457 Main Street

Card access upgrade project

Addendum 1: Replacement of automated doors actuators

Appendix 2. Node 1.12

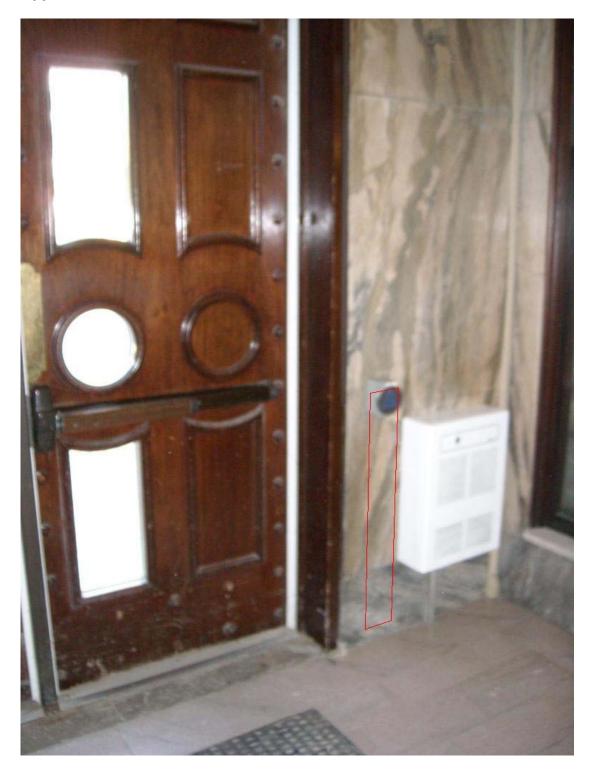
Exterior wall. Node 1.12. Planned actions:

- Remove the existing automated door actuator button and the mounting box
- Mount a Wikk Access Ability's 36" The Ingress'r Column Touch Actuator (dark bronze finish) (Appendix 1) as shown in Appendix 2. The goal is to cover the existing actuator mounting holes with the new device
- Patch any exposed mounting holes

Appendix 4. Node 1.14

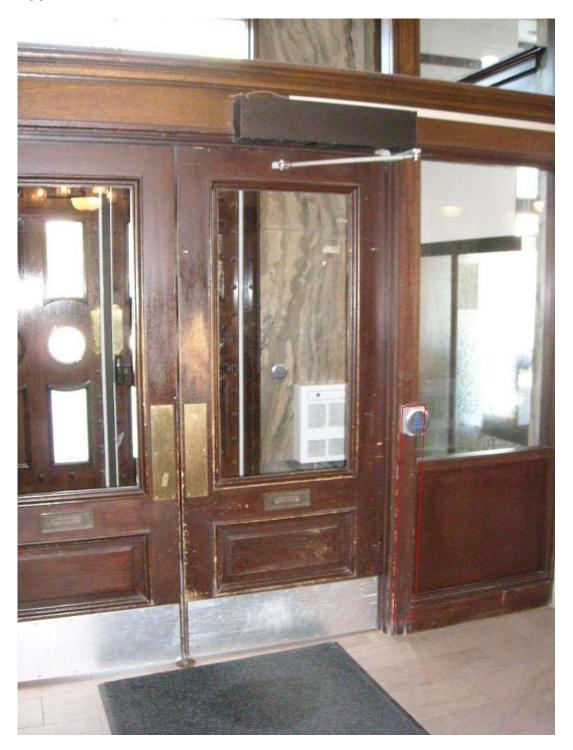
Vestibule. Node 1.14. Planned actions:

- Remove the existing automated door actuator button and the mounting box
- Mount a Wikk Access Ability's 36" The Ingress'r Column Touch Actuator (dark bronze finish) (Appendix 1) as shown in Appendix 4. The goal is to cover the existing actuator mounting holes with the new device
- Patch any exposed mounting holes
